DART AEROSPACE LTD	Work Order:	94356
Description: Crosstube Assembly (412 High Aft)	Part Number:	D412-664-243
Inspection Dwg: D412-664-243 Rev: E		Page 1 of 2

DRAWING NO. D412-664-243	TITLE CROSSTUBE ASSEMBLY (412 HI AFT)	REV. E	DART AEROSPACE LTD ENGINEERING ORDER		D.E.O. NO. D412-664-243-E-1	SHEET NO. SHEET 1 OF 2	SCALE NTS
DRAWN	CHECKED	MFG. APPR.	APPROVED	DE APPR.			
DATE 11.03.31	DATE 11/03/31	DATE 11.03.31	DATE 11/03/31	DATE 11-03-31

DRAWING NO. D412-664-243	TITLE CROSSTUBE ASS'Y (412 HI AFT)	REV. E	DART AEROSPACE LTD ENGINEERING ORDER		D.E.O. NO. D412-664-243-E-2	SHEET NO. SHEET 1 OF 1	SCALE NTS
DRAWN 9P	CHECKED ASS	MFG. APPR. E	APPROVED MP		DE APPR. H		
DATE 11.09.07	DATE 11.09.19	DATE 11.09.19	DATE 11.09.19		DATE 11.09.19

DRAWING NO. D412-664-243	TITLE CROSSTUBE ASSEMBLY (412 HI AFT)	REV. E	DART AEROSPACE LTD ENGINEERING ORDER		D.E.O. NO. D412-664-243-E-4	SHEET NO. SHEET 1 OF 3	SCALE NTS
DRAWN 90	CHECKED A	MFG. APPR. A	APPROVED MP		DE APPR. MP		
DATE 12.08.21	DATE 12.08.30	DATE 12.08.30	DATE 12/8/30		DATE 12.08-30

**D412-664-243
ASSEMBLY DETAIL**

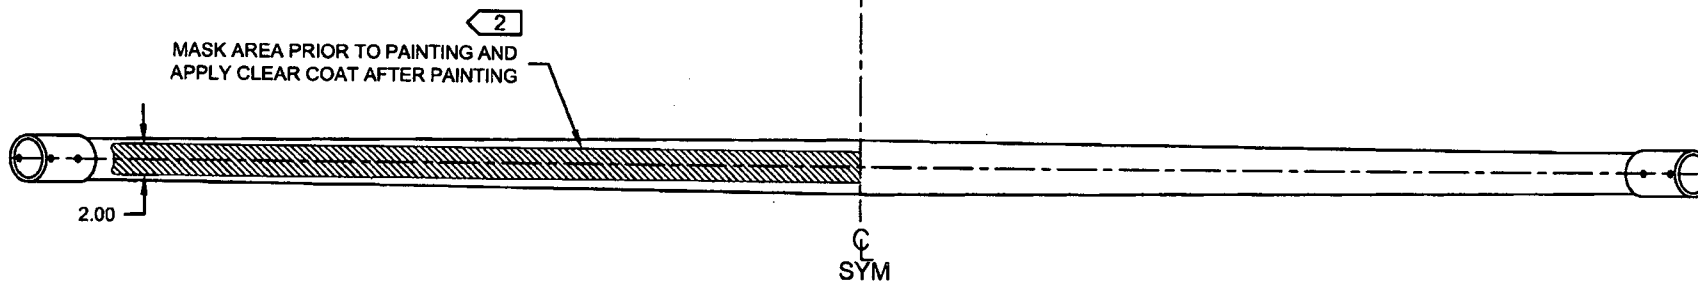
PURPOSE:

REMOVED ABRASION STRIP IN FAVOR OF A THIN LAYER OF PROSEAL 890.

IS:

D3189-1 CHAFING SHIELD (1, INSTALLED OVER PROSEAL 890)
MS21920-28 CLAMP, 2X
2 PL

WAS:

D2856-600-1009 ABRASION STRIP
D3189-1 CHAFING SHIELD (1, INSTALLED OVER ABRASION STRIP)
MS21920-28 CLAMP, 2X
2 PL

**D412-664-243
ASSEMBLY DETAIL**

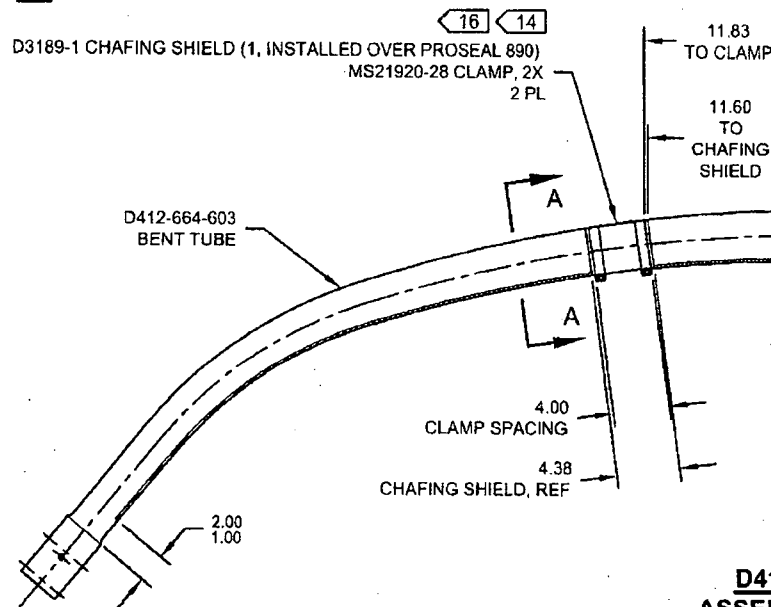
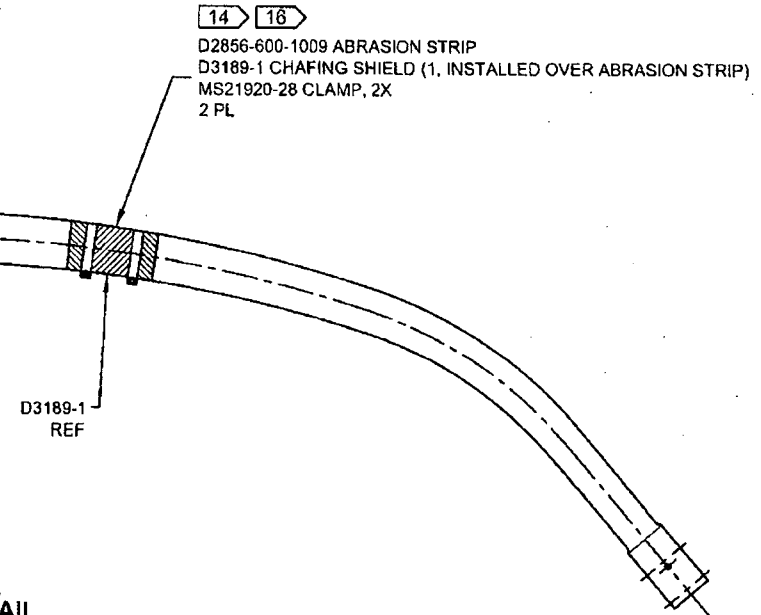
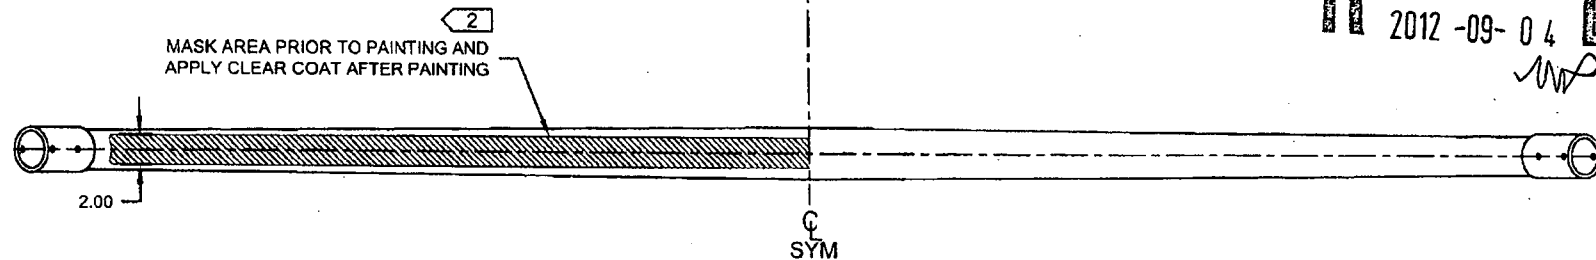
PURPOSE:

REMOVED ABRASION STRIP IN FAVOR OF A THIN LAYER OF PROSEAL 890. UPDATE INSTALLATION OF CHAFING SHIELDS AND REDUCE TORQUE TO 40-50 IN-LBS. THIS ENGINEERING ORDER SUPERCEDES DEO D412-664-243-E-1.

IS:

WAS:

SECTION A-A
CHAFING SHIELD DETAIL
VIEW ROTATED, NOT TO SCALE

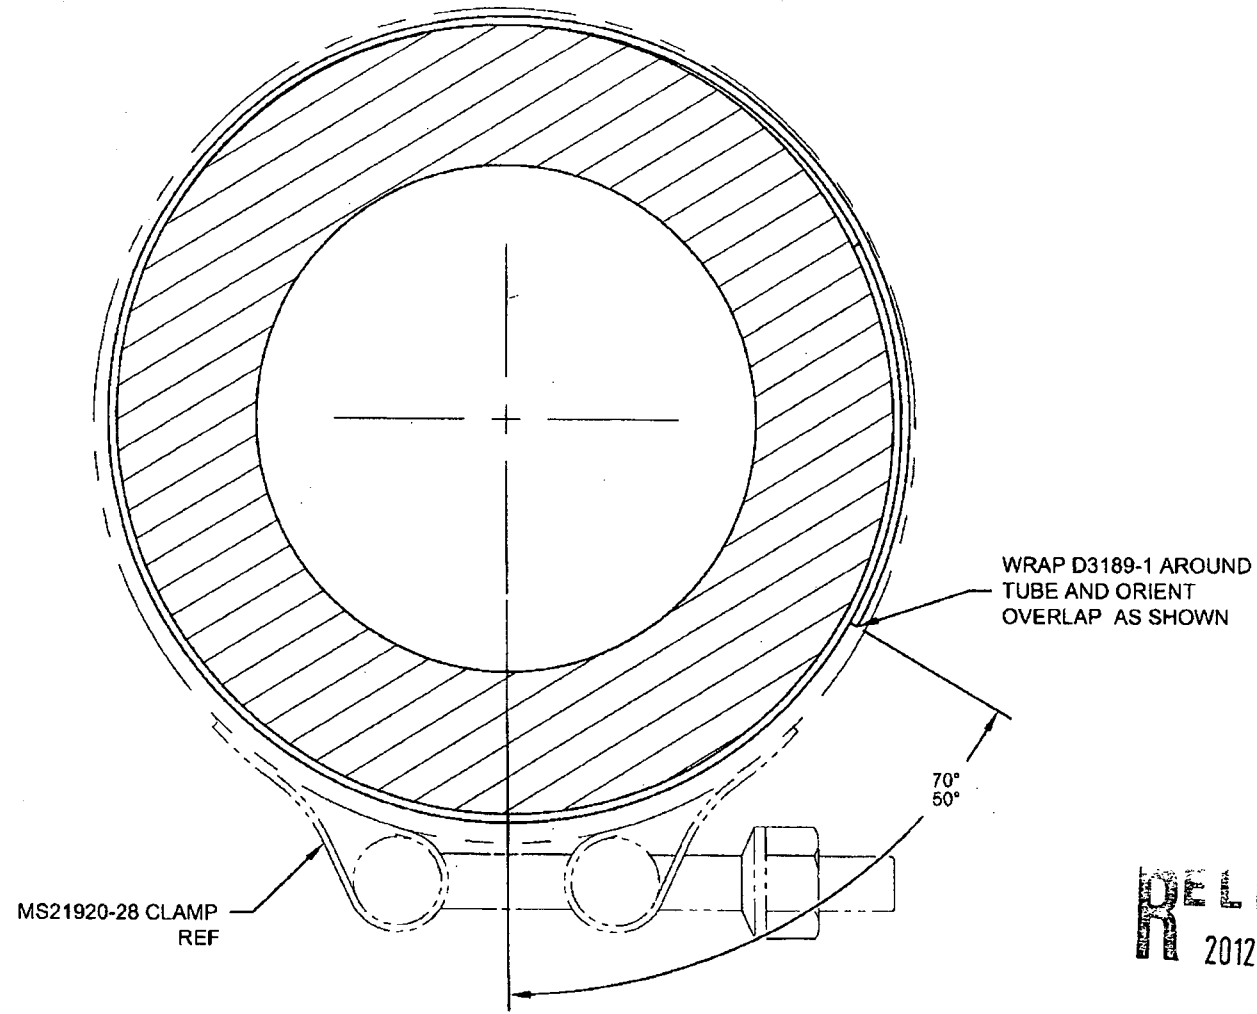
- 2) FINISH: CHEMICAL CONVERSION COAT PER DART QSI 005 4.1
PRIME INSIDE AND OUTSIDE PER DART QSI 005 4.2
MASK UNDERSIDE OF CROSSTUBE AS SHOWN (HATCHED AREA)
PAINT OUTSIDE PER DART QSI 005 4.2
AFTER PAINTING, APPLY CLEAR COAT ON HATCHED AREA
- 14) APPLY A THIN COAT OF PROSEAL 890 ON INSIDE CONCAVE SURFACE OF D3189-1 CHAFING SHIELD AND LET CURE PER MANUFACTURER'S INSTRUCTIONS. INSTALL PROSEALED D3189-1 CHAFING SHIELD ONTO CROSSTUBE BY APPLYING A THIN COAT OF PROSEAL 890 ONTO CROSSTUBE. BE SURE TO ELIMINATE ANY AIR GAPS.
- 16) TORQUE CLAMPS ON D2896-1 SUPPORT 80 TO 100 IN-LB. **TORQUE CLAMPS ON D3189-1 CHAFING SHIELD 40 TO 50 IN-LB.** ENSURE AT LEAST 1.5 THREADS SHOWING IN SAFETY AND THAT NUT HAS NOT BOTTOMED-OUT AFTER TORQUING.
